Subject: Response to TCCS Comments – Driveways, Streetlight, Trees, Waste, and Pedestrian Network

Project: Block 10 Section 54 Red Hill

DA Reference: DA-202544282

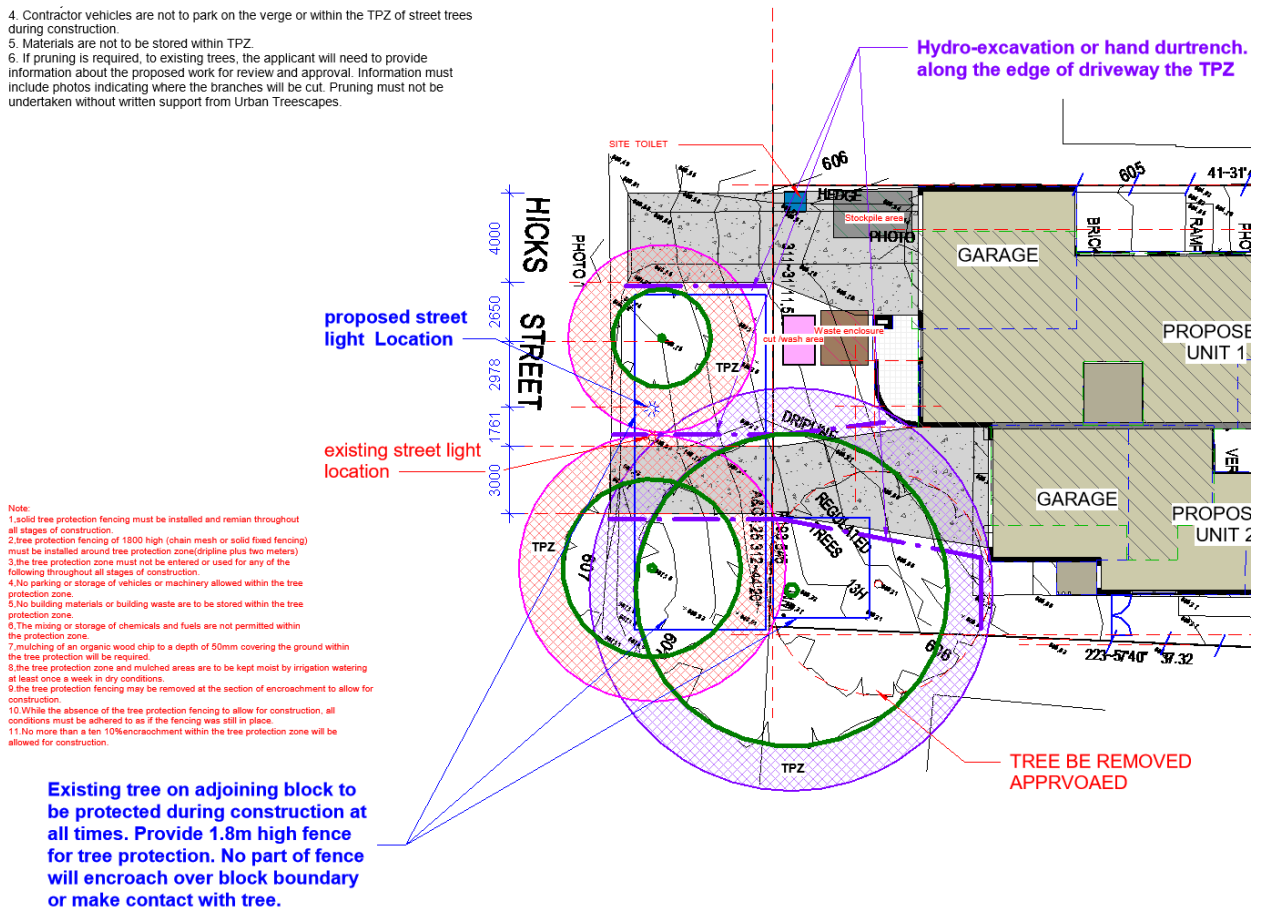
Driveways

- Driveway 1 will be reduced from 5 m to 4 m as requested.
- Driveway 2 will remain at 3 m due to constraints related to the relocation of the streetlight.
- The driveway crossing will be designed and constructed in accordance with TCCS MIS Design Standards, with no alterations to existing verge levels.
- Garage and driveway levels will be graded to prevent bottom scraping of small cars, with transition zones designed in accordance with AS 2890.1, Appendix C.
- A clear sight triangle will be provided on site plan also driveway plan
- Post-DA, the driveway will be inspected at the formwork stage by a TCCS officer.
